Relates to PL/2025/04909 PP

Discharge of conditions 3 (Schedule of works for repairs to the historic fabric), 5 (Detailed doors schedule), 6 (Drainage and plumbing runs) and 7 (Details of materials for new shopfront and link extension) of PL/2025/04909.

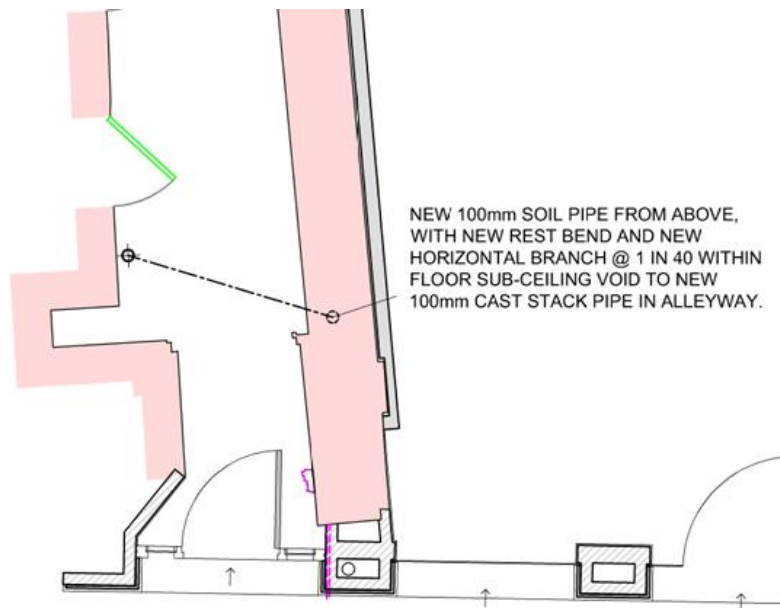
Where is this information?

What has been provided? Plan 1556/09

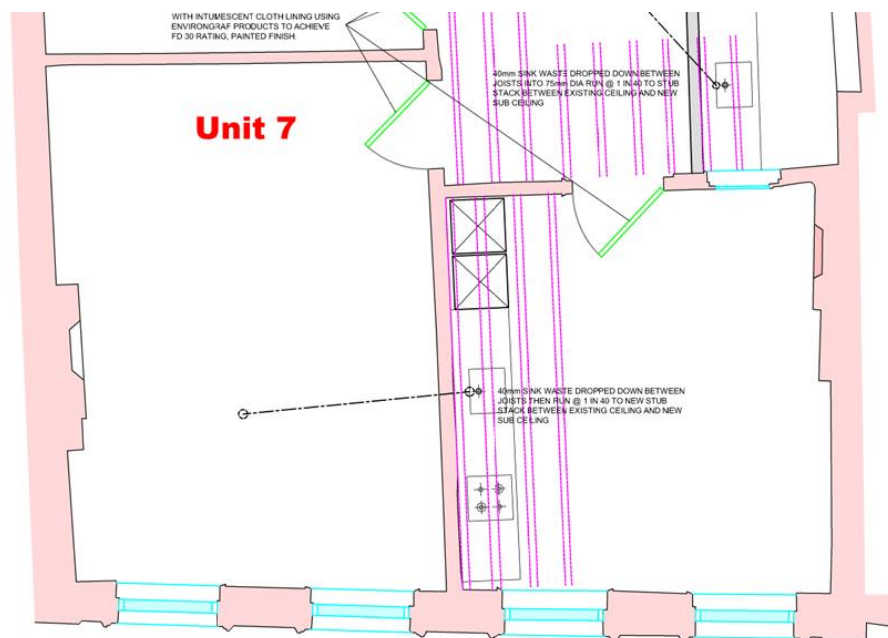
Can they confirm that this arrangement (see below) does not affect the sunken bath?

Are they really proposing a diagonal run of pipework from room X to room X (unit 7)? (Yes, wouldn't it be helpful to have the rooms numbered?).

Also, what happens here below? They go through or under the wall and through or under the joists? Please clarify.
